**CITY OF LEWISTON**  
**PLANNING BOARD MEETING**  
Monday, August 22, 2016 – 5:30 P.M.  
City Council Chambers – First Floor  
Lewiston City Building  
27 Pine Street, Lewiston, ME

**Development Review Application – VIP Warehouse Parking Expansion**  
**Response to Staff Review**  
**12 Lexington Street, Lewiston, Maine**

**City Planner Comments dated August 11, 2016**

15124SWP - PRE  
 V.P. WAREHOUSE PARKING EXPANSION  
 12 LEWISTON STREET  
 LEWISTON, MAINE  
 V.P. INC.  
 LEWISTON, MAINE 04240

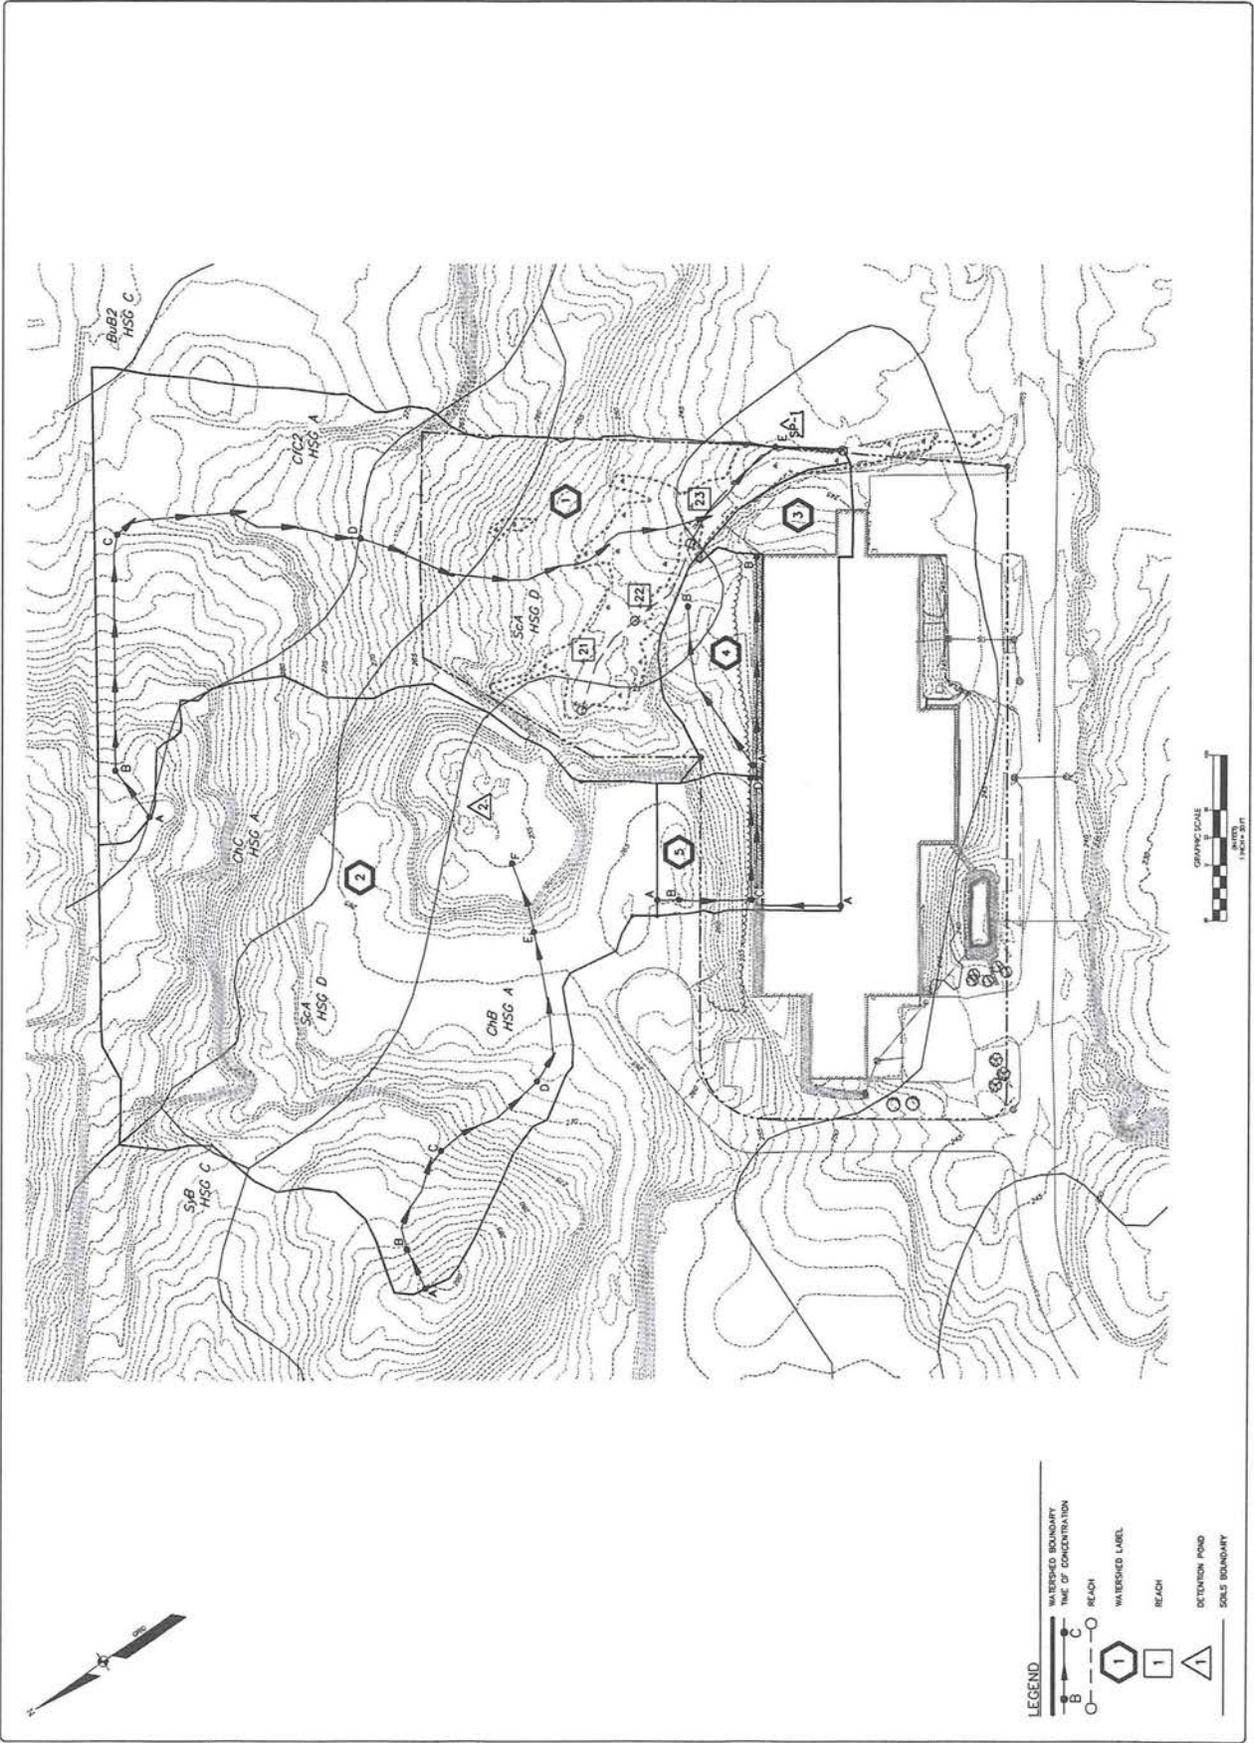
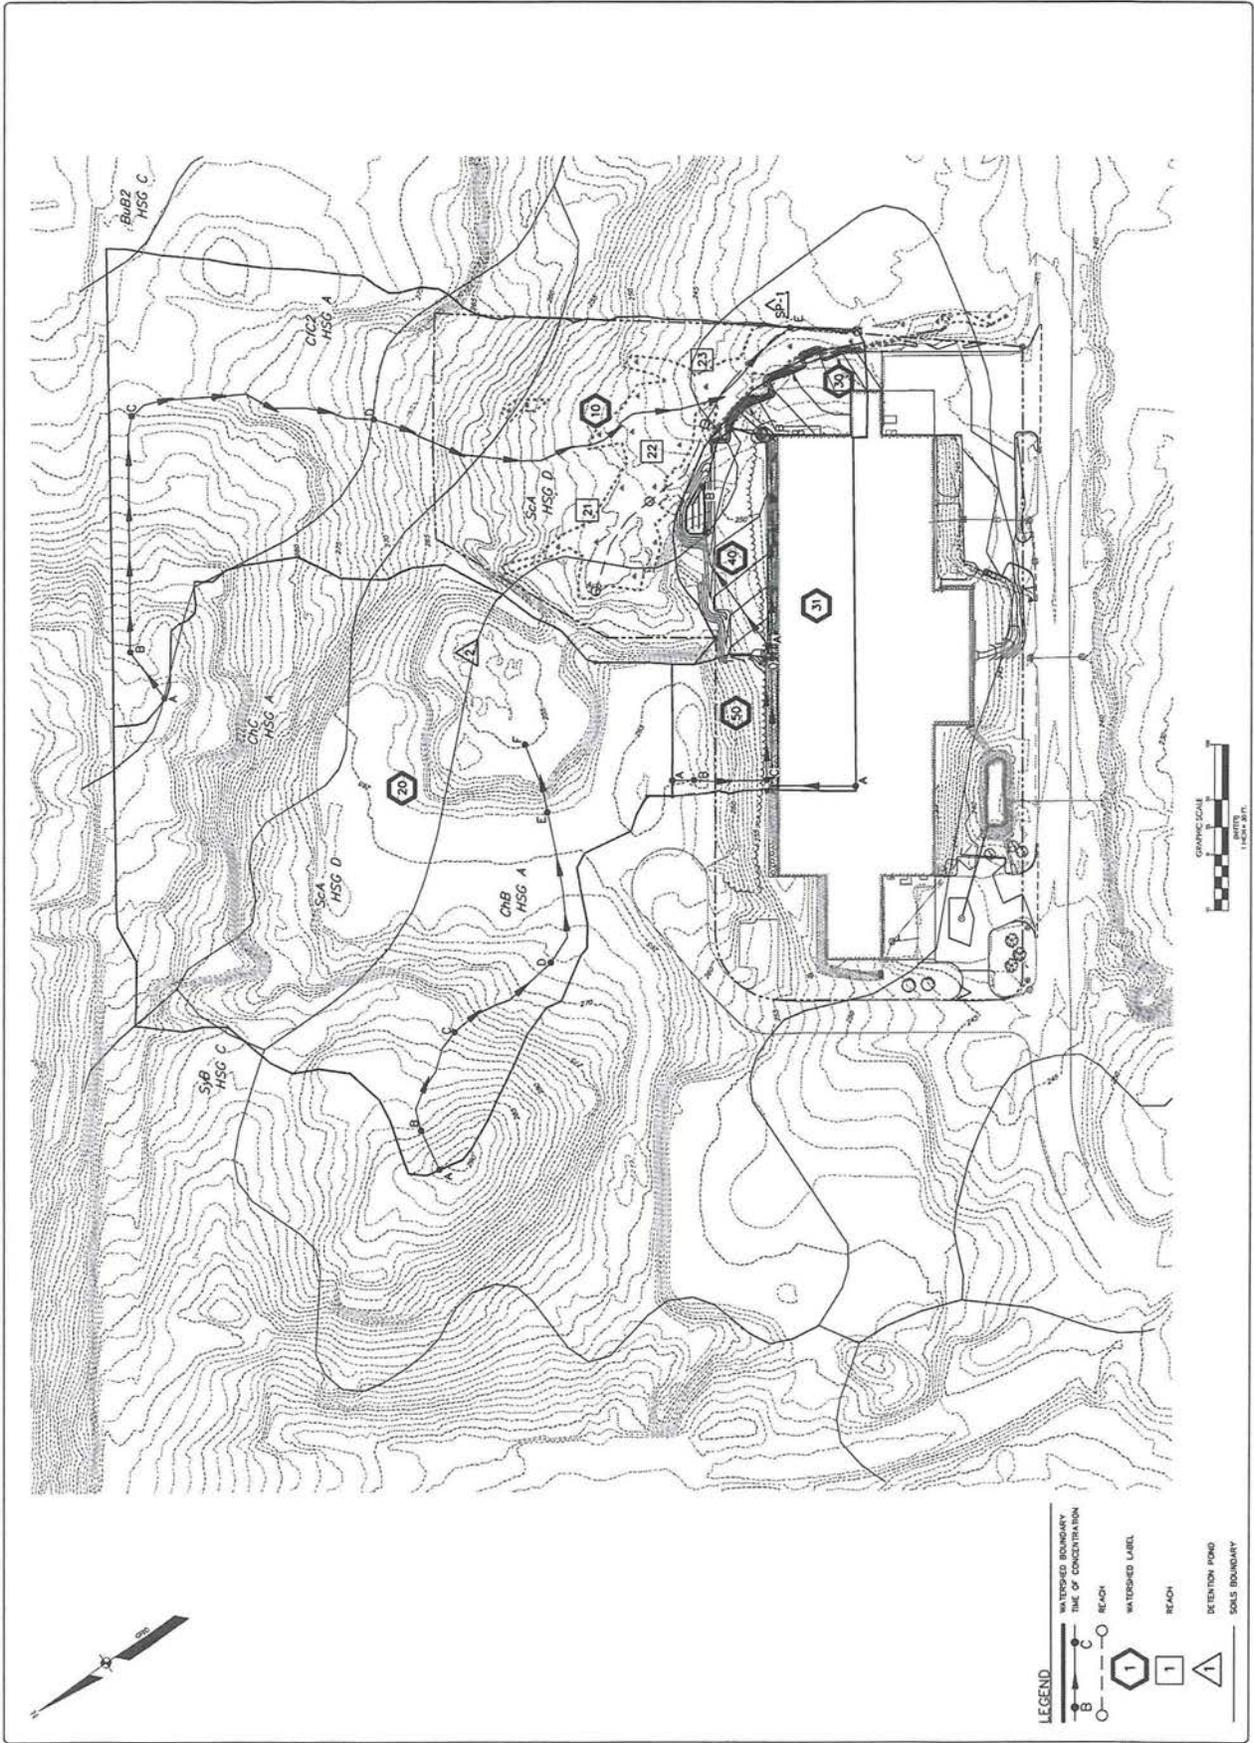
5. *Stormwater Management Plan:*

- a. *Section III. A – Was a site law modification completed for this existing gravel parking area?*

The existing records of the approved development are limited. It is not clear if this was included in the original 1986 approval. It was not addressed in the 2000 amended site plan approval.

Photographs from 1988 provided by the applicant show the area in part to be gravel surfaced in 1988. The stormwater management plan has been revised based on the assumption that the area was not permitted. Due to the elevation of the site and the proximity of wetlands in is not practicable to provide stormwater treatment for this area. The revised plan includes the construction of a drip edge filter BMP to provide treatment for existing impervious area to meet the General Standards and the payment of a compensation fee to meet the Urban Impaired stream standards.

The stormwater analysis has been revised to use the City Ordinance rainfall of 4.6" in place the current MDEP Chapter 500 rainfall depth of 4.3". Revised calculation and a revised stormwater management report are attached there is no significant change in the results of the analysis. The calculated peak rate of runoff is reduced in the post development condition for all storm events evaluated.

NEW INSTALLATION  
NOT TO SCALE

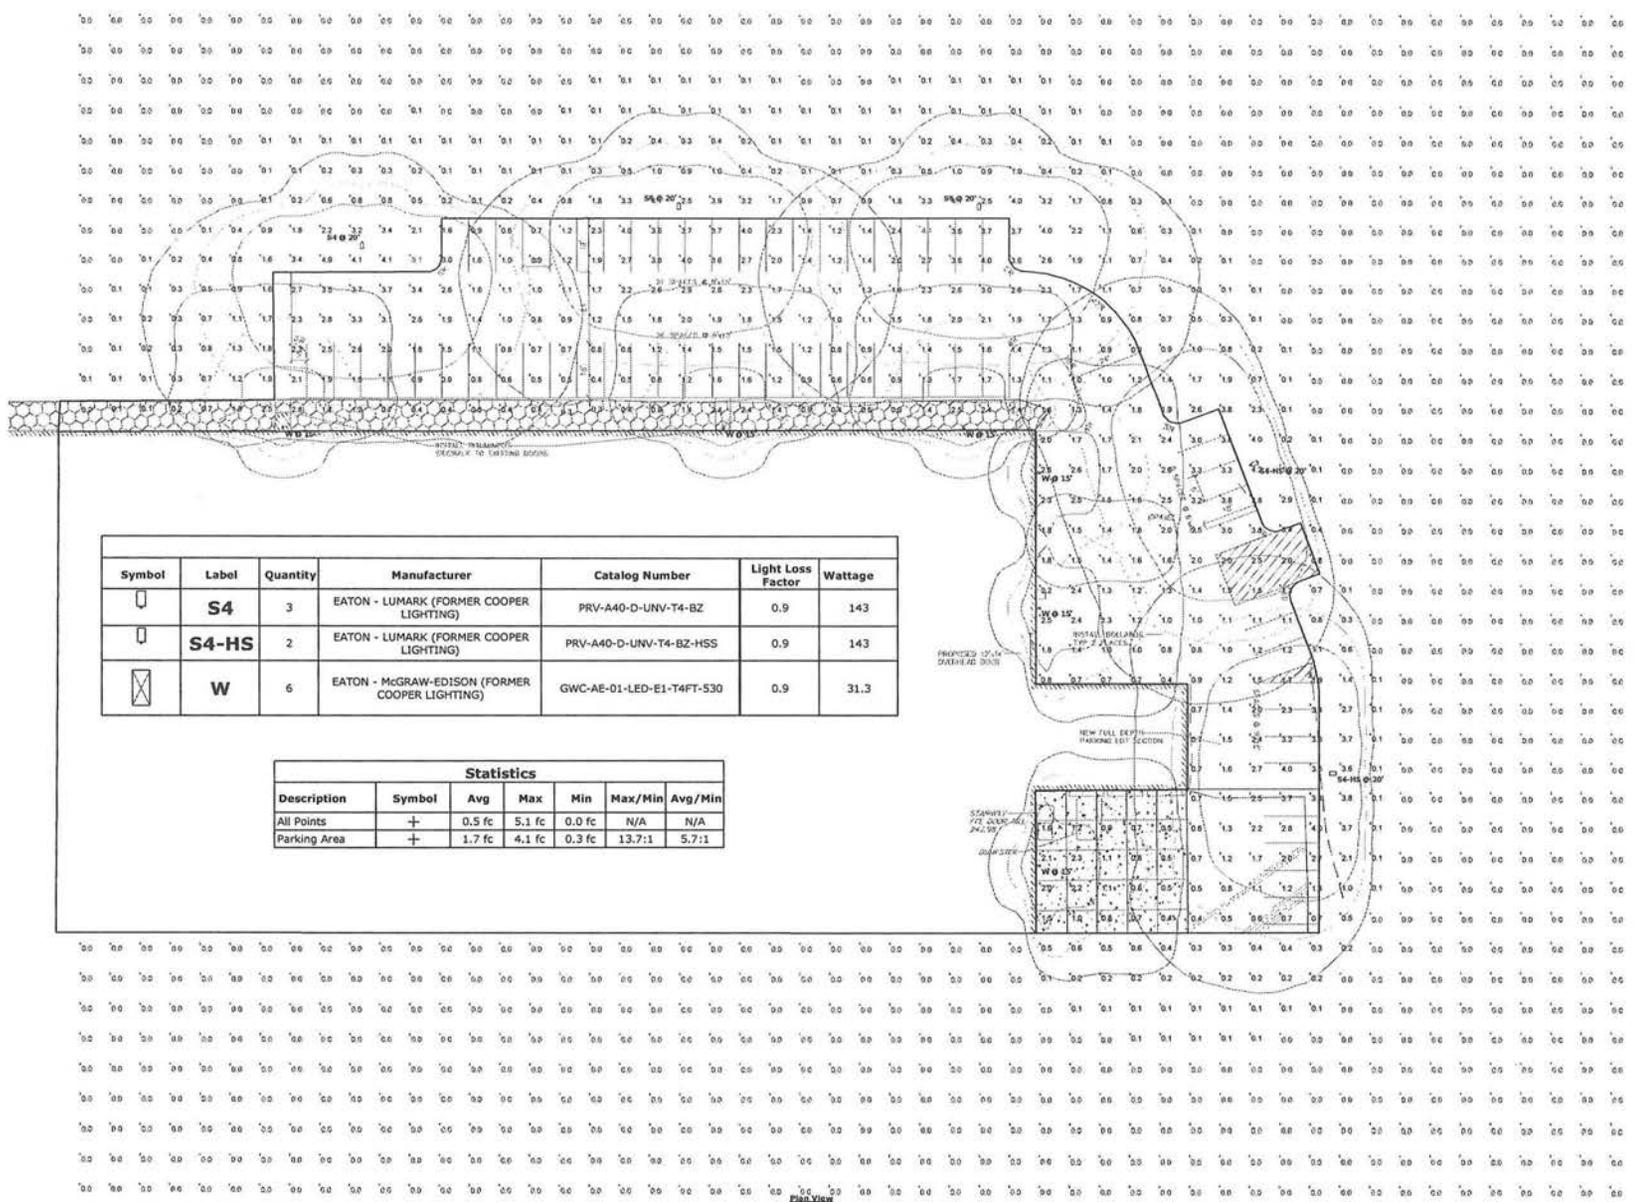
3. *Drip Edge Swale Detail:*

- a. *It appears based on the detail that the applicant is proposing to utilize the existing underdrain and foundation material rather than install a new underdrain and underdrain layer. Has the condition of this pipe and stone backfill been verified?*

The existing foundation drain was recently repaired by the applicant. The detail has been revised to include a new underdrain for the filter to address concerns related to the existing backfill material. A low permeability soil and fabric layer are proposed to minimize roofline drainage into the foundation drain. As noted in previous comments and in the revised detail notes. The design engineer will inspect the installation to confirm the backfill conditions,
